**J99343SF AND J99343SG**  
**SINGLE FREQUENCY SIGNALING/4-4 WIRE REPEATER**  
**INSTALLATION AND TESTING**  
**METALLIC FACILITY TERMINAL**

**1.001** This addendum supplements Section 332-912-251, Issue 2. Place this pink sheet ahead of Page 1 of the section.

Fig. 2.1—Component Layout of the J99343SG, L2 CFU

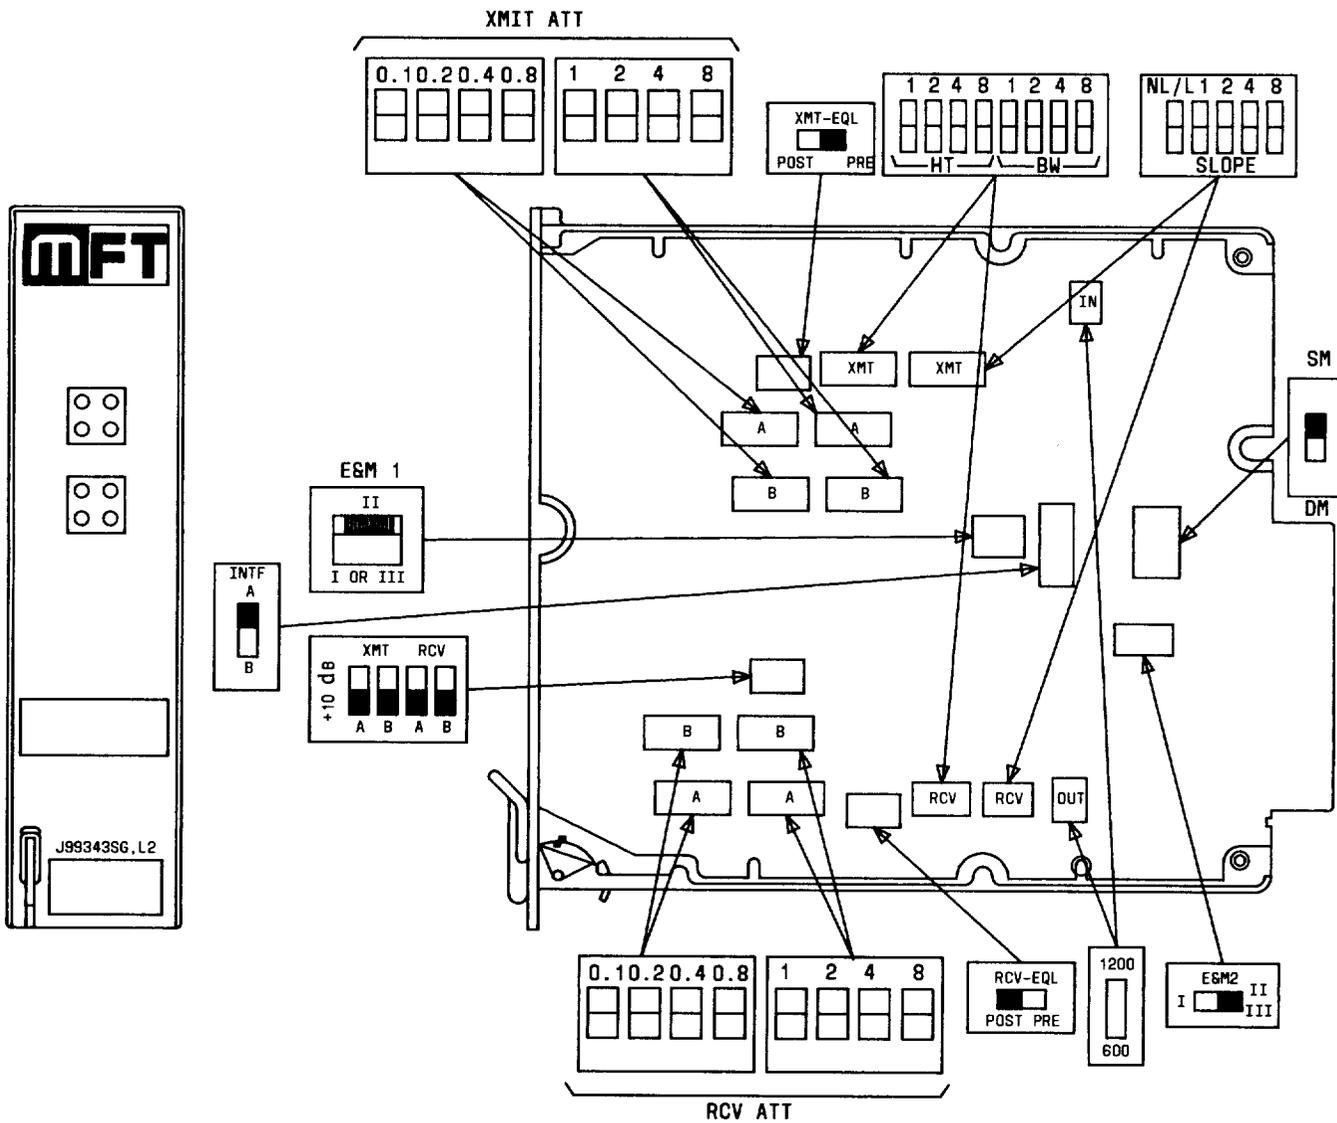
**2.003** Add new Fig. 2.1 shown in this addendum.

**2.005** All text, illustrations, and procedural references to the J99343SG CFU starting with paragraph 2.10 will imply both the List 1 and List 2 versions except paragraphs 2.10 and 2.11 which describe the gain, slope HT, and BW switches as rocker-type switches. The J99343SG, L2 CFU uses slide-type DIP (dual in-line package) switches.
